**The Camden (Waiting and Loading Restrictions) (Civil Enforcement Area) (Amendment No. 103) Traffic Order 2019**  
**The Camden (Parking Places) (CA-D) (Amendment No. 28) Traffic Order 2019**  
**The Camden (Parking Places) (Car Clubs) (Amendment No. 18) Traffic Order 2019**  
**The Camden (Loading Places) (Amendment No. 28) Traffic Order 2019**  
**The Camden (Prescribed Routes) (No. 6) Traffic Order 2019**  
**The Camden (Parking Places) (CA-G) (Amendment No. 24) Traffic Order 2019**  
**The Camden (Parking Places) (CA-L) (Amendment No. 12) Traffic Order 2019**  
**The Camden (Parking Places) (Dedicated Disabled) (Amendment No. 42) Traffic Order 2019**

## **BRUNSWICK SQUARE – PROPOSED WALKING AND CYCLING IMPROVEMENTS**

## **STATEMENT OF REASONS**

Project  
 Brunswick Square WC1  
 Central London Cycle Grid

Scale 1 : 1500 @ A1	Date 20/05/2019
Drawn By NHS	File Ref -
Checked By YK	Dwg Name -
Drawing Location -	
Drawing Number 2019_20-BS-DD-100-TMO1	Rev. -

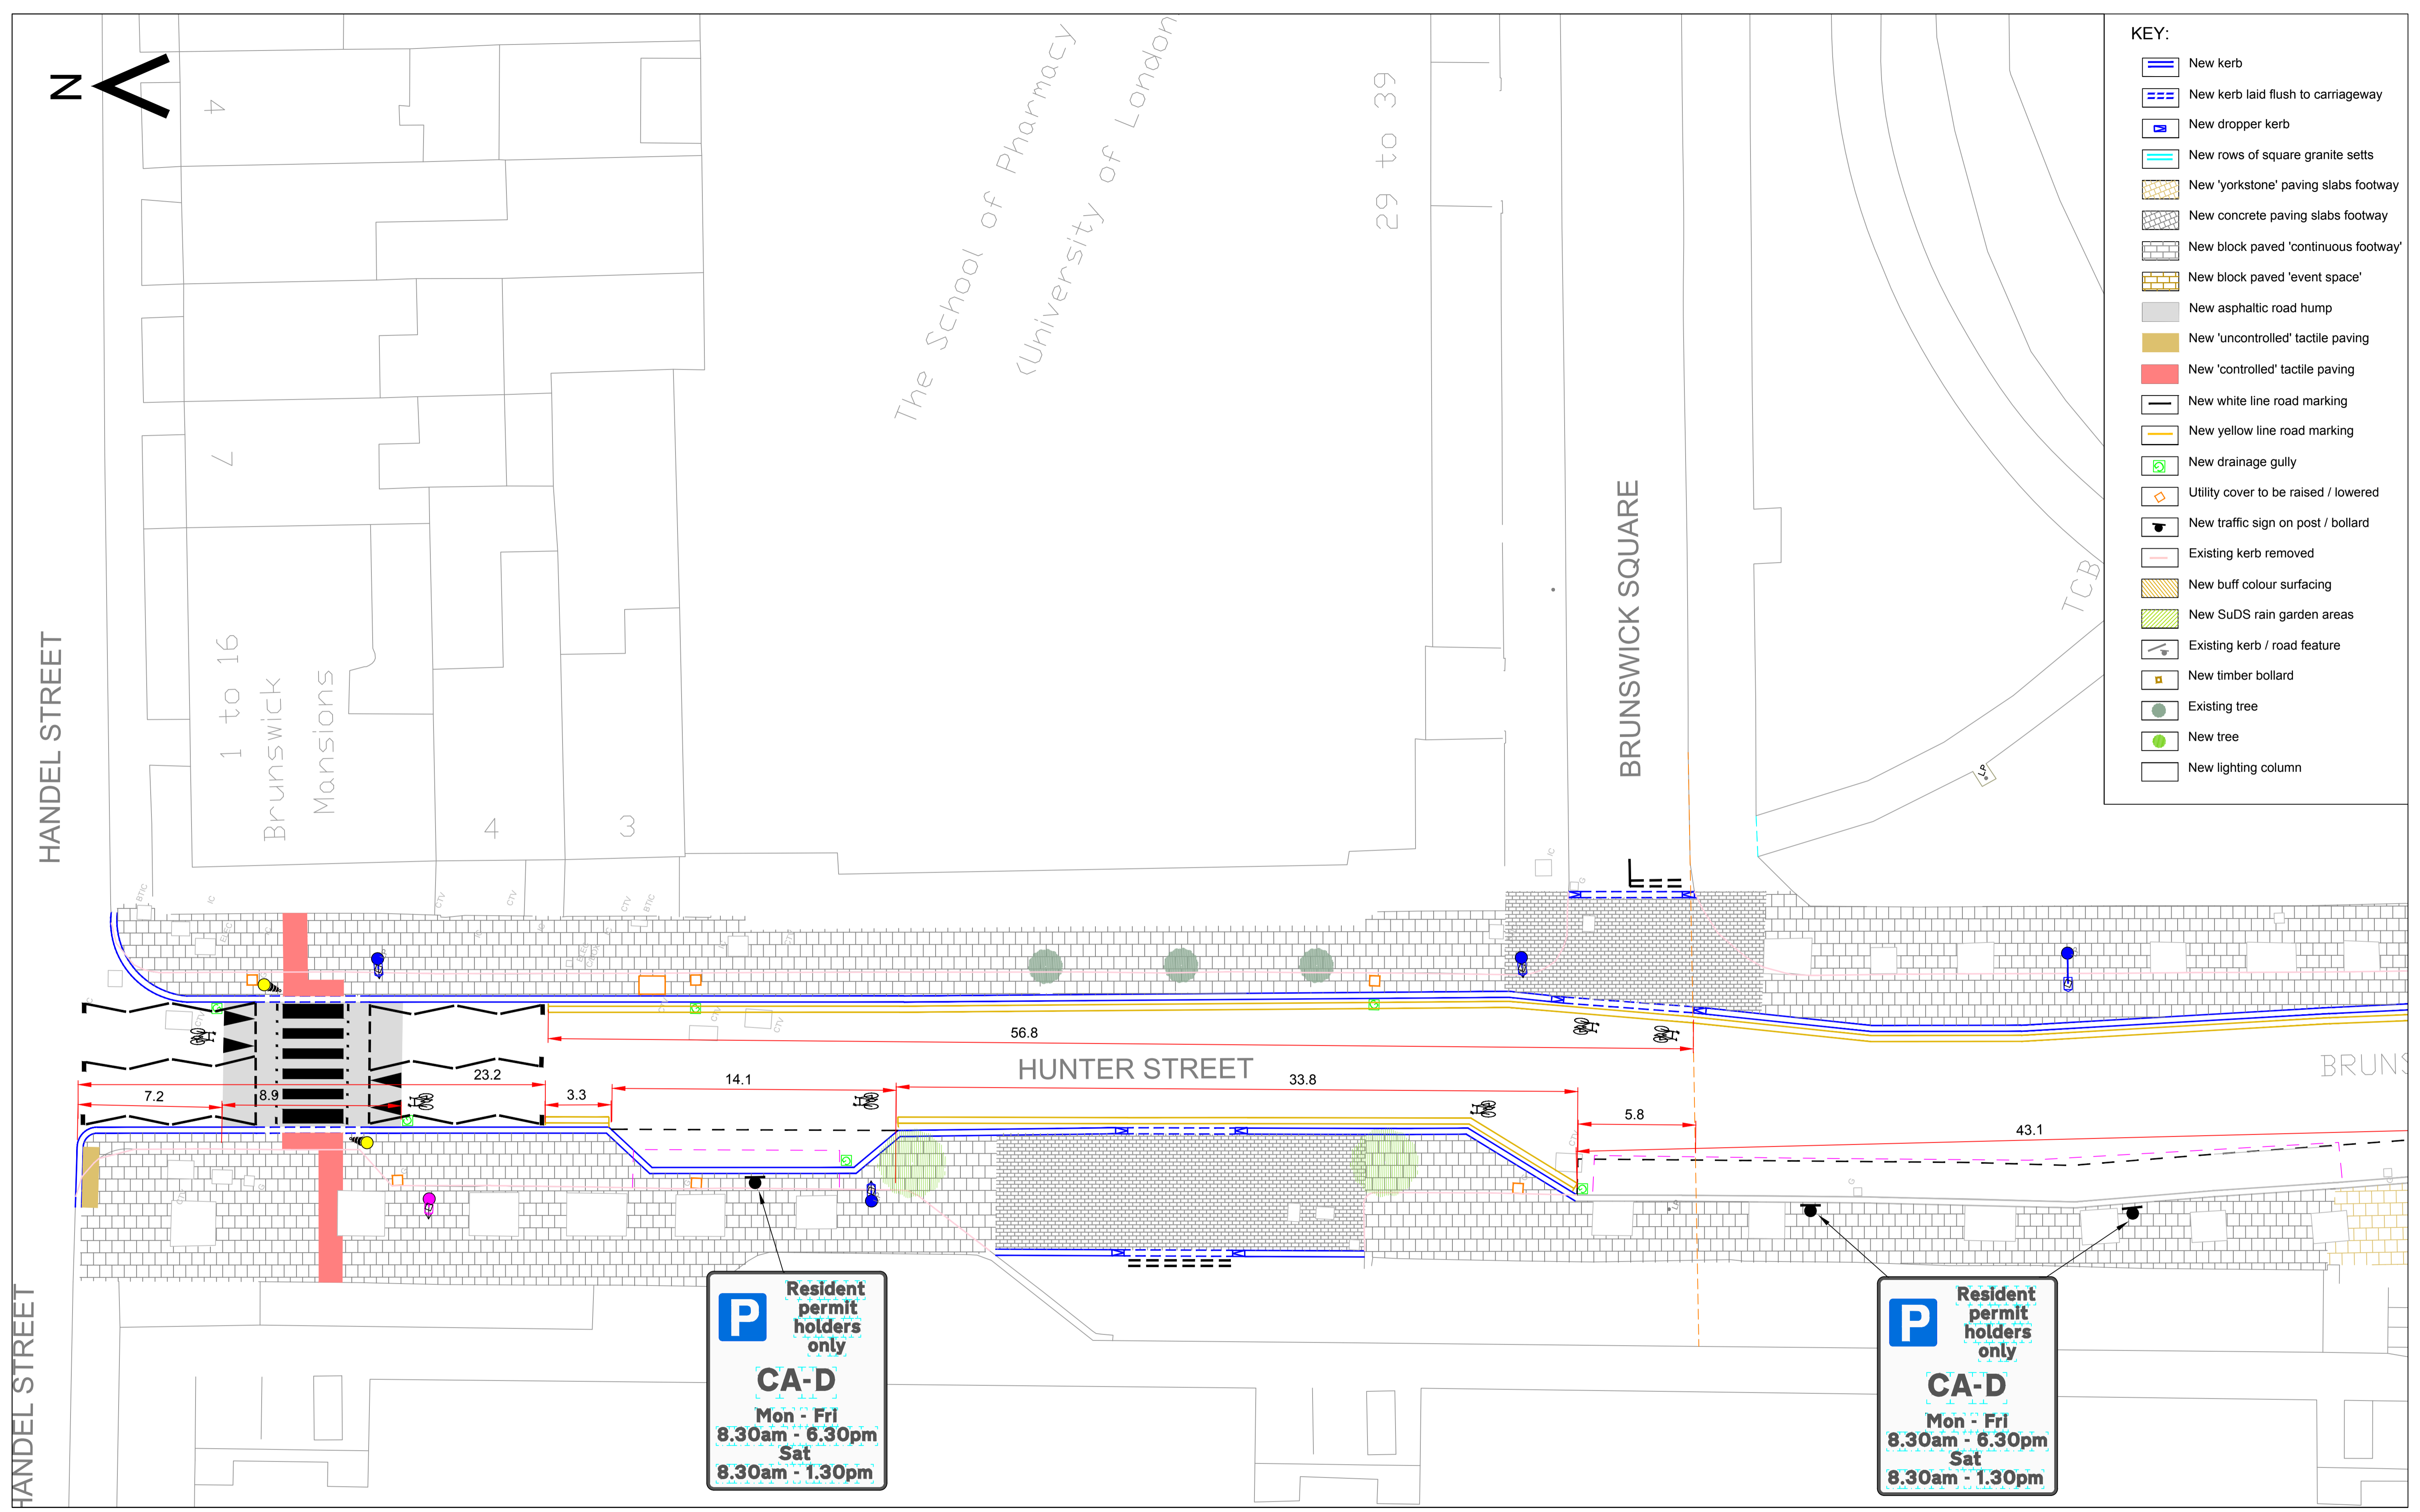
All vehicular travel into and out of the south-east arm of Brunswick Square to be prohibited at its junction with the south-west arm of Brunswick Square / Grenville Street / Bernard Street. Movement along the south-westernmost 25 metre section of the south-east arm of Brunswick Square to be permitted for cyclists only.

**North-east side:** motorcycle parking place, 3.5 metres length  
residents permits parking place, 30.5 metres length  
loading bay, 9 metres length

**South-east side:** motorcycle parking place, 5.7 metres length  
residents permits parking place, 24 metres length  
residents permits parking place, 14.8 metres length

**South-west side:** residents permits parking place, 43.1 metres length

**North-west side:** residents permits parking place, 35.3 metres length

**South-east side:** residents permits parking place approximately 20 metres length  
Car Club parking place approximately 15 metres length

**South-west side:** residents permits parking place, 36.9 metres length  
motorcycle parking place, 10.1 metres length

Drawing Title  
**New no loading 'at any time'  
 restriction**

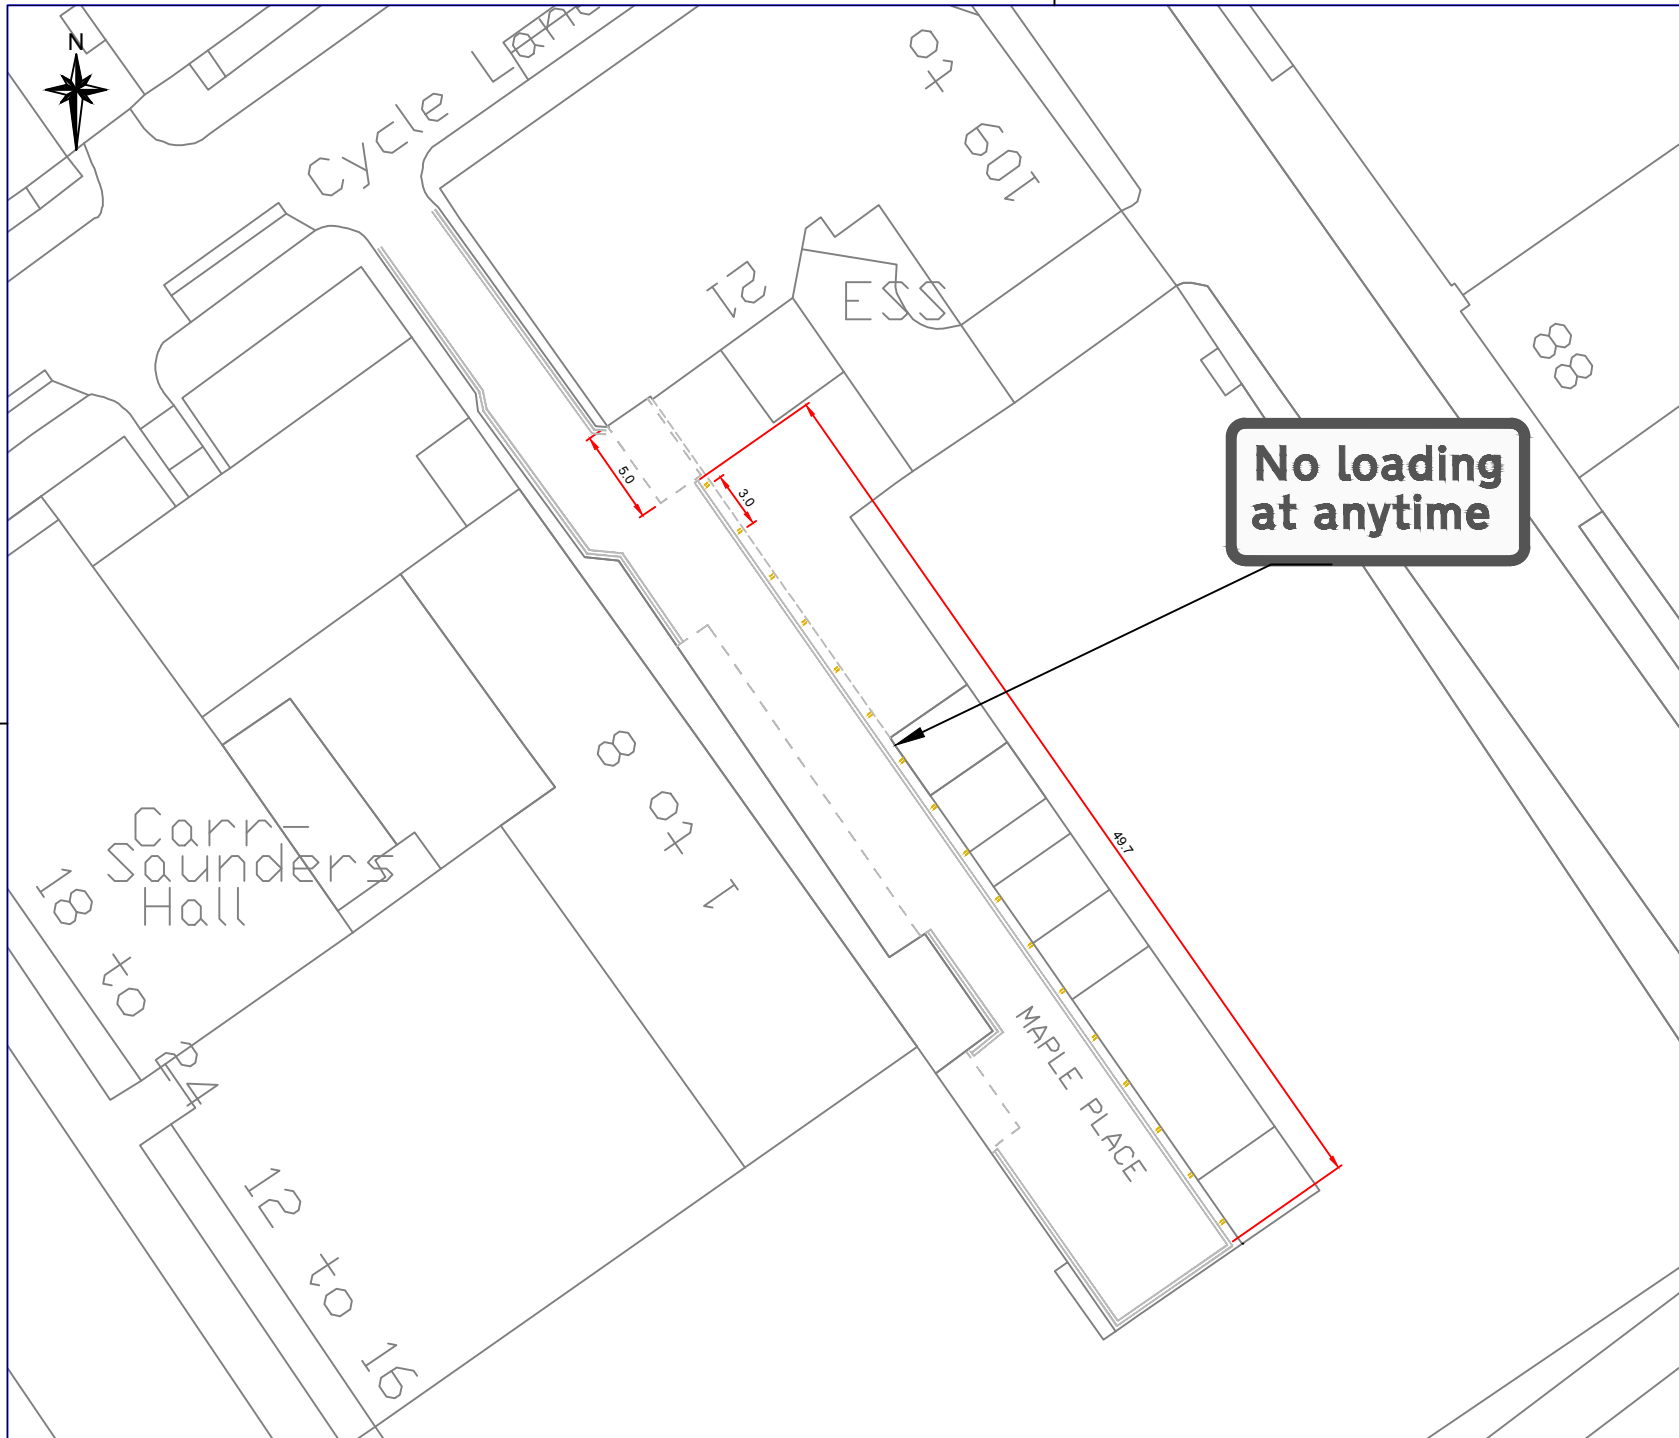
Introduction of 24 hour loading ban on the east side of the street.

A loading ban is proposed on the eastern side of the street to ensure access to storage units is kept clear.

## Doric Way/Werrington Street Amendments

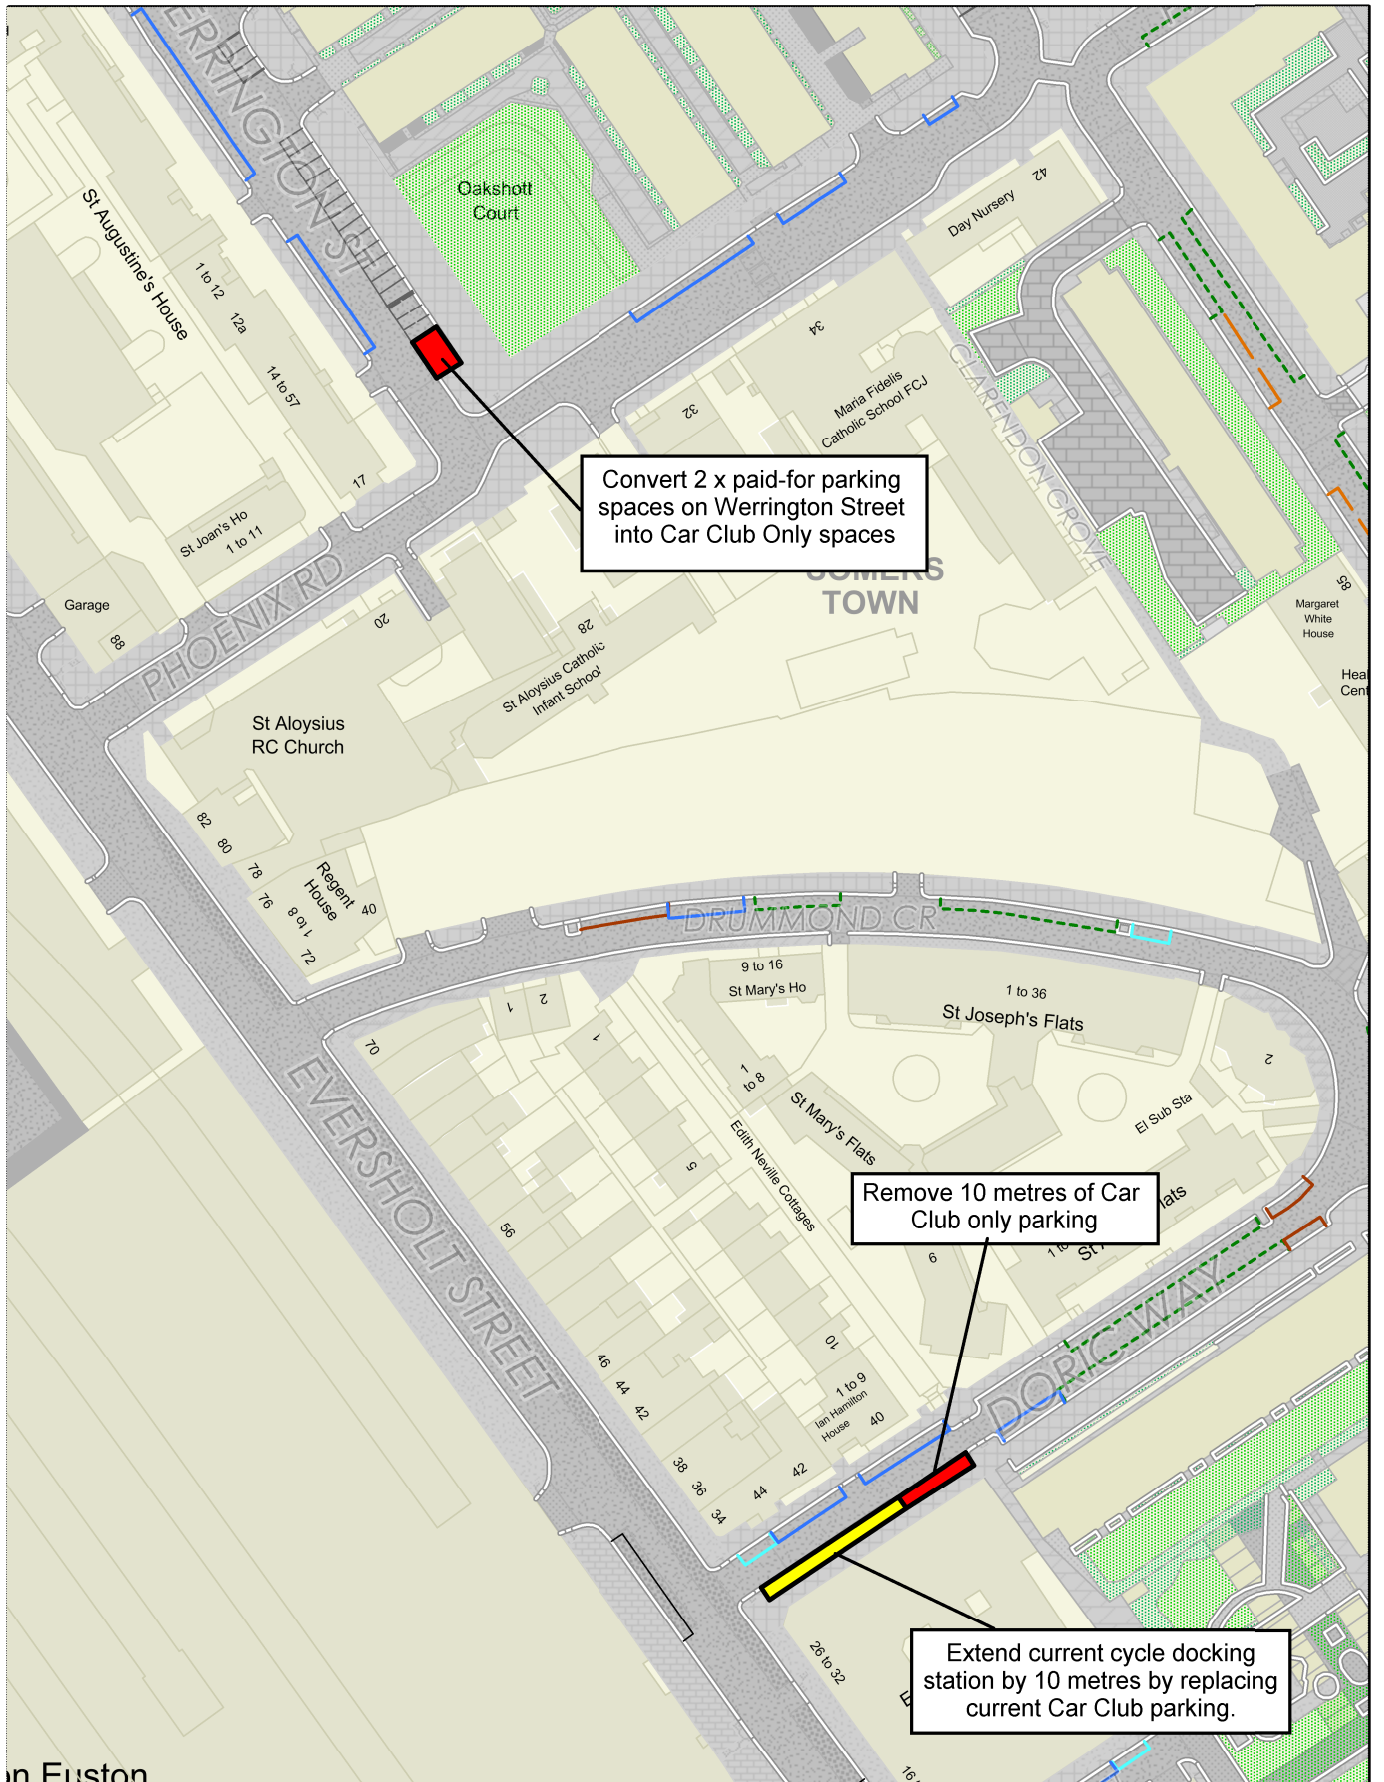
Relocation of the Car Club parking place from Doric Way to the three southernmost echelon paid-for parking spaces outside Oakshott Court, Werrington Street.

The designated Car Club parking place in Doric Way is to be relocated to Werrington Street to enable the extension of the adjacent cycle docking station.

# Proposed dedicated disabled parking bay

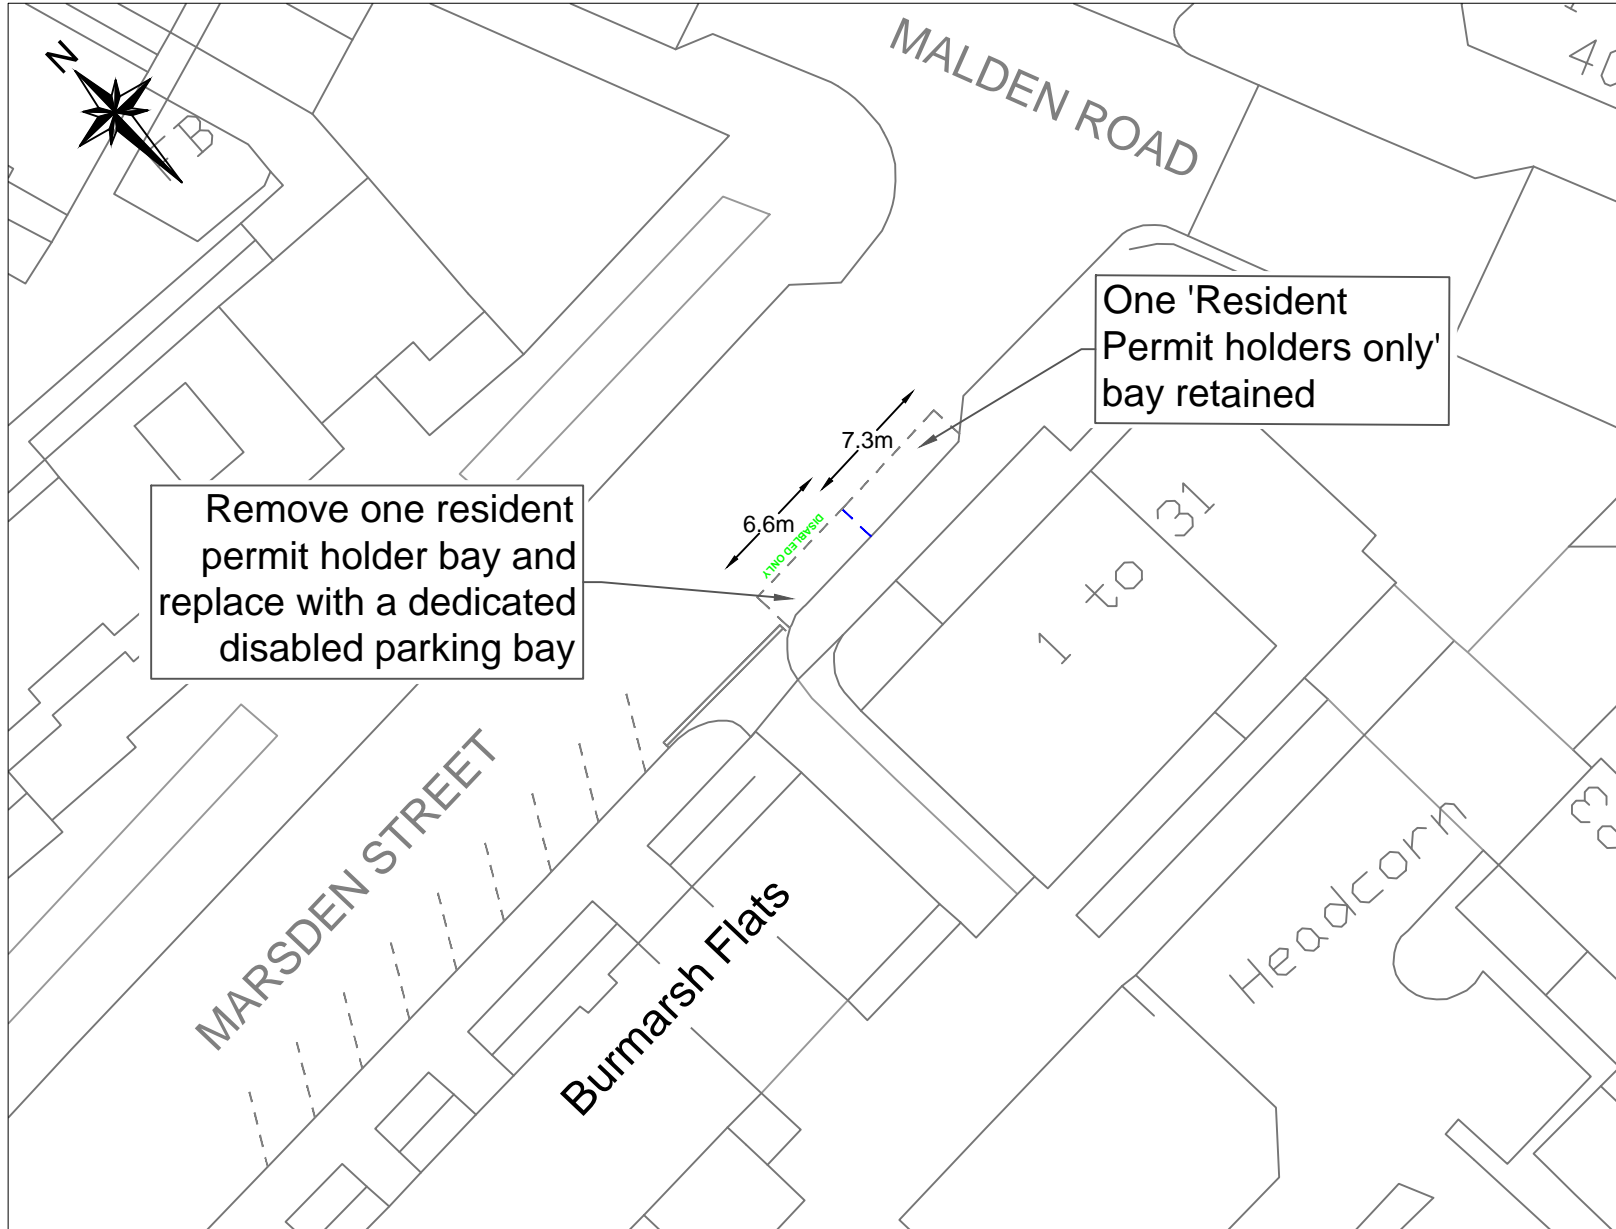
Conversion of one of the residents parking spaces at the side of Headcorn, Malden Road, to a dedicated disabled person's parking space.

A dedicated disabled parking place is being provided for an individual who, on application, has met the criteria for the provision of the parking place.
